**IECC COMMERCIAL COMMITTEE ACTION REPORT ON THE RESULTS  
ON THE 2022  
PUBLIC COMMENTS/CODE CHANGES TO PUBLIC COMMENT DRAFT 1  
TO THE INTERNATIONAL ENERGY CONSERVATION CODE-COMMERCIAL (4/28/23)**

Figure 1. Heat pump chiller piped in series

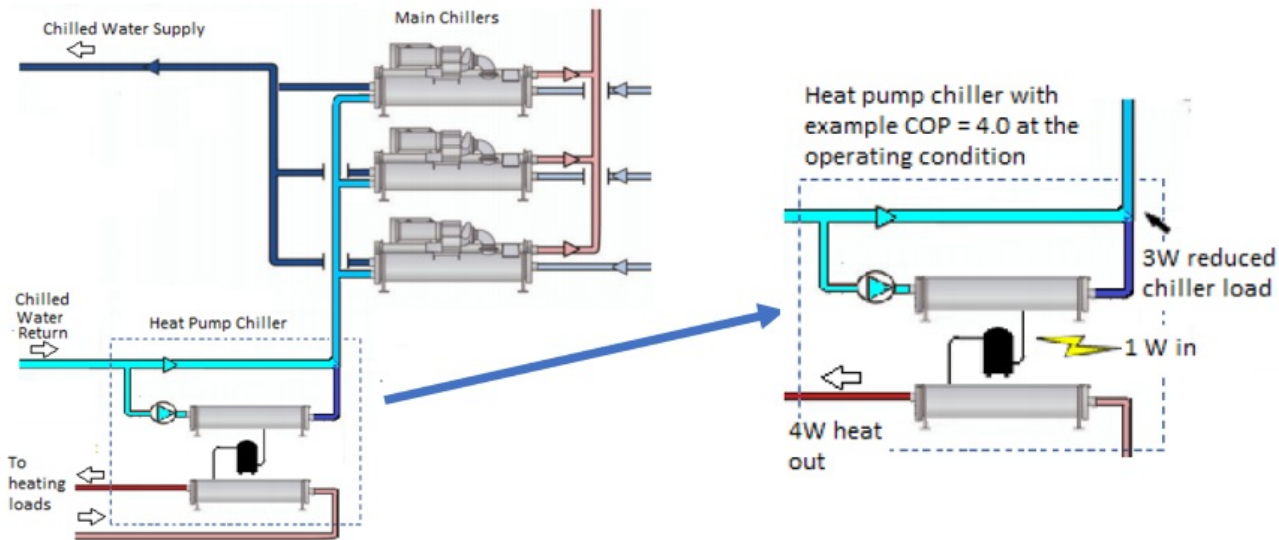
**Reason:** Section C403.11.6, "Heat Recovery for Space Conditioning in Healthcare Facilities," requires heat recovery in most acute inpatient hospitals. The existing language refers to "condenser heat recovery." The heat source was intended to be the chilled water return, and the economic justification was built on that. The diagram shows a parallel and in-series system. Both are acceptable ways to meet the requirement.

Figure 2. Heat pump chiller piped in parallel

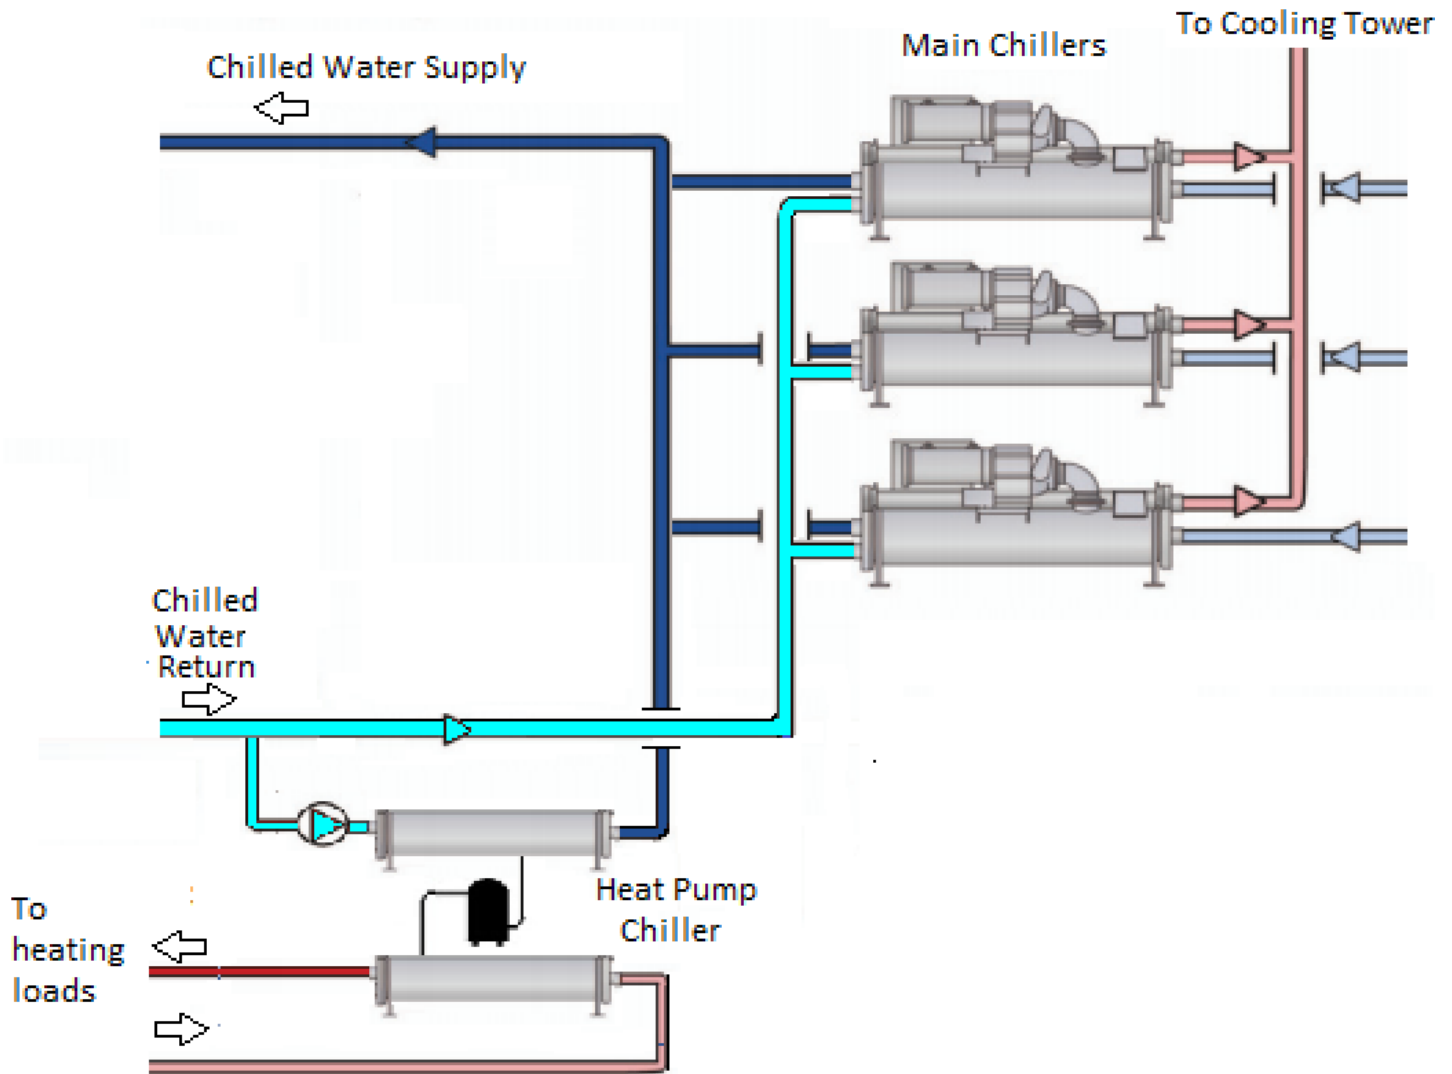
The term “condenser heat recovery” has led some users to believe that the heat source can be water leaving the main chiller condenser. While this method does recover heat, it does not reduce the load on the chillers. Using the chilled return water as the heat source saves much more energy.

Fig. 1: Comparing site EUI of fossil fuel and electric heat pump buildings using DOE prototype models

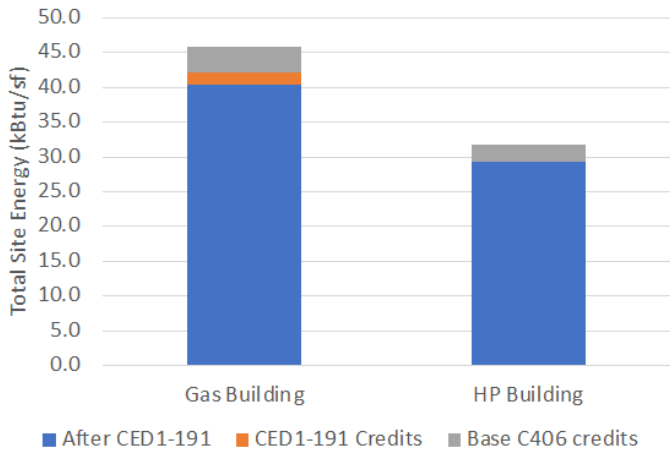
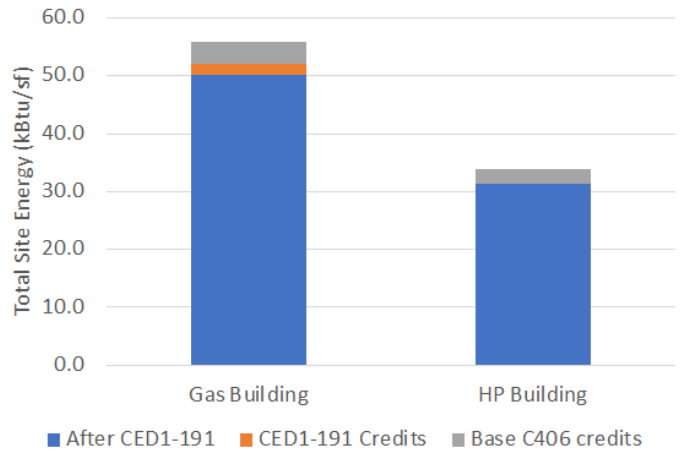
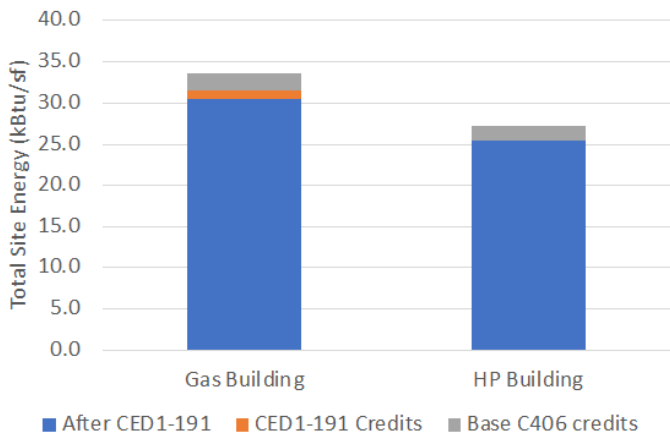
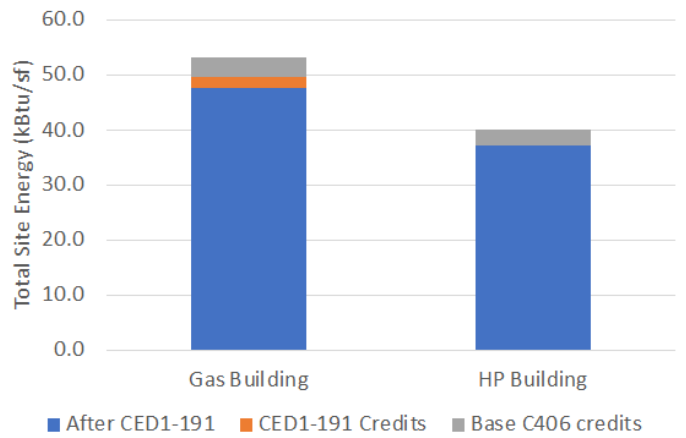
The number of credits that the original proponent of these changes (PNNL) set for Section C406 were determined based on a cost-effectiveness test using an unreasonably high 9.3% nominal discount rate. The Commercial Consensus Committee approved cost-effectiveness criteria of both a 5.3% nominal discount rate and a 9.3% nominal discount rate. The 5.3% discount rate is much more appropriate for this analysis. For PNNL's original submission, they used an 8% nominal discount rate and proposed a set of credit requirements more than 14% higher (area-weighted average by building type and climate zone) than those in the public review draft. A straight line extrapolation would yield 43% higher credit requirements; because the discount rate effect is non-linear, it is reasonable to expect the level of cost-effective credits required to comfortably exceed 50% above those in the public review draft. Although detailed data is not available from PNNL, further analysis using the outputs of PNNL's cost-effectiveness analysis and the DOE prototype models indicates that an additional 25% higher energy efficiency credits would have to cost an average of 12.2 times the upfront cost of the base credits to violate the cost-effectiveness criteria with a 9.3% nominal discount rate (16.6 times the base credits' upfront cost with a 5.3% nominal discount rate, as shown in Fig. 2). A similar analysis was presented to the Commercial Consensus Committee for an additional 50% credit requirement; here it's even stronger at 25% and excluding Storage spaces. The public review draft's Appendix CF includes an "Advanced Energy Credits Package" double that of the Section C406 requirements, which PNNL determined to be the maximum credits a jurisdiction could reasonably require. Taken together, this indicates that 50% higher energy efficiency credits would be rather easily cost justified regardless of the heating and hot water systems.

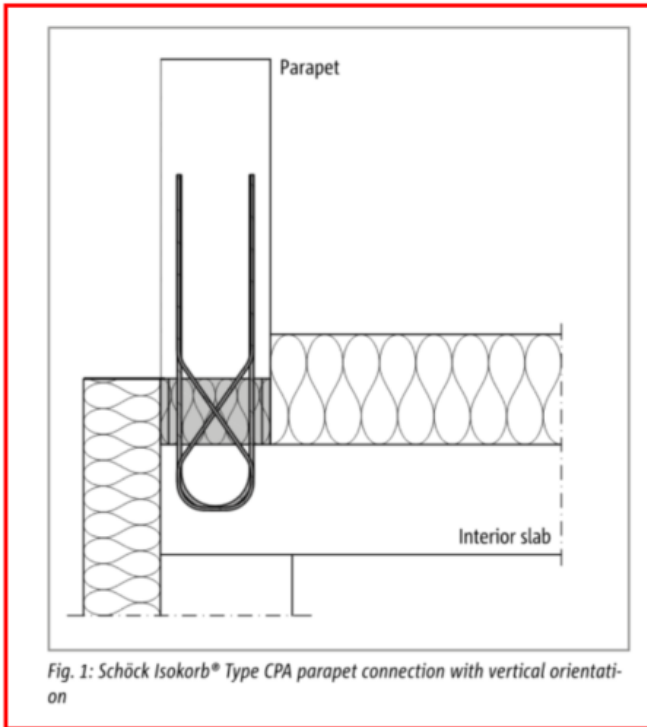
The proposed wording will make it feasible to meet thermal performance requirements with current structural thermal break products on the market.

The tweaks to the wording clarify that a manufactured structural thermal break is acceptable and that the R-value applies only to the **insulated material** of the manufactured assemblies.

ISOKORB T TYPE CPA: STRUCTURALLY ANCHORS THE PARAPET INTO THE TERRACE/ROOF SLAB AND MAINTAINS CONTINUOUS INSULATION THROUGH THE PARAPET

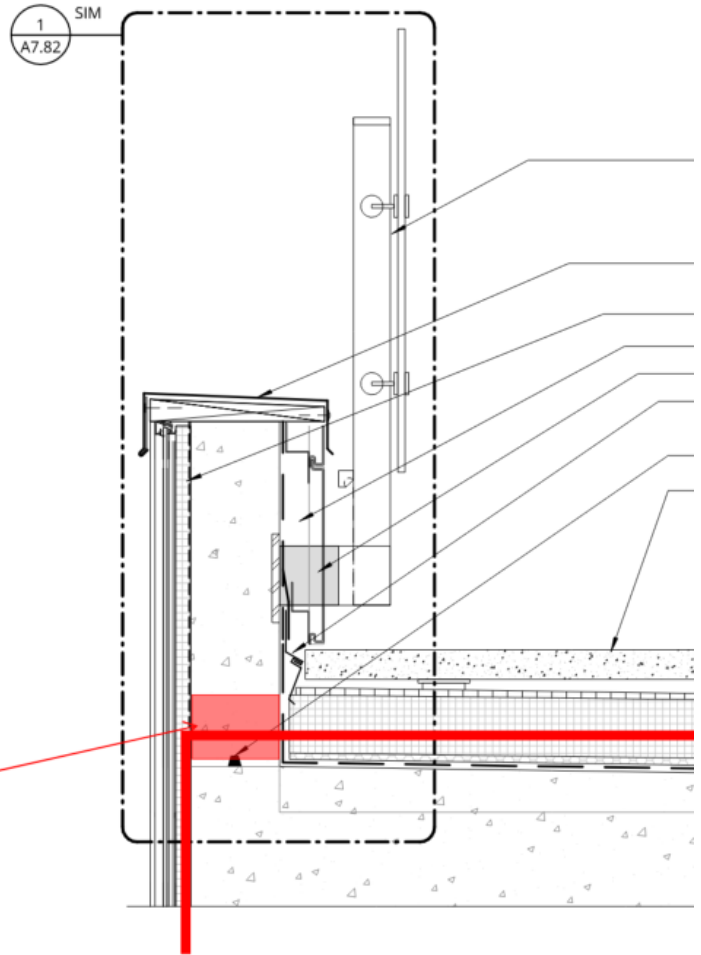
Regarding parapets with adding C402.7.5.5, incorporating a structural thermal break within the parapet ensures a truly continuous building envelope compared to extending insulation 2' up along the parapet.

See below image for where a structural thermal break can be incorporated at a parapet to maintain continuous insulation:
